# DUKE POWER COMPANY

Re: Oconee Nuclear Station  
Docket Nos. 50-269, 50-270, 50-287

Pursuant to 10 CFR 50, Section 50.90, an amendment to Section 6.1 of the Oconee Nuclear Station Technical Specifications, Appendix A to Facility Operating Licenses DPR-38, -47, and -55 is proposed. Specifically, please find attached a proposed change to Figure 6.1-1 entitled "Station Organization Chart". This chart is referenced by Technical Specification 6.1.1.3 and depicts the station organization for Operations, Technical Services, and Maintenance. Proposed changes to the station organization as reflected by this chart are as follows:

OCONEE NUCLEAR STATION  
STATION ORGANIZATION CHART  
FIGURE 6.1-1

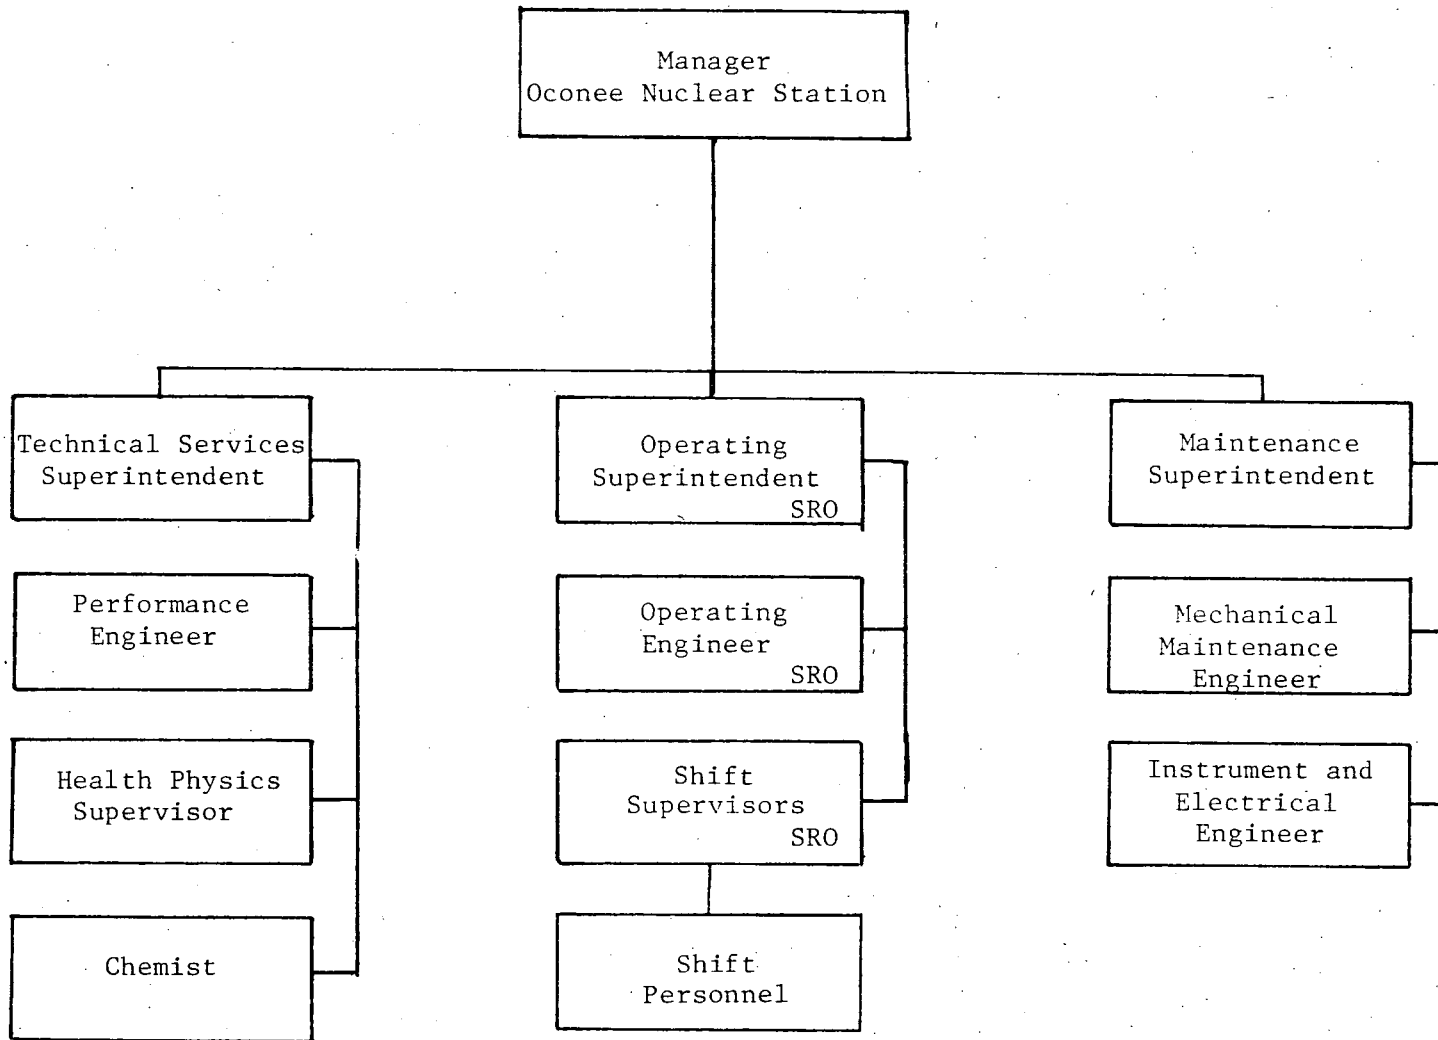
The "Instrument and Control" section has been redesignated as the "Instrument and Electrical" section, and the "Maintenance" section has been redesignated as the "Mechanical Maintenance" section.

By redistributing personnel assignments, the Maintenance Organization is more effectively divided into two more distinct branches, with one branch responsible for only mechanical maintenance and the other only for electrically-related maintenance. This reorganization provides a more logical assignment of maintenance personnel and thereby will afford a more efficient overall Maintenance Organization.
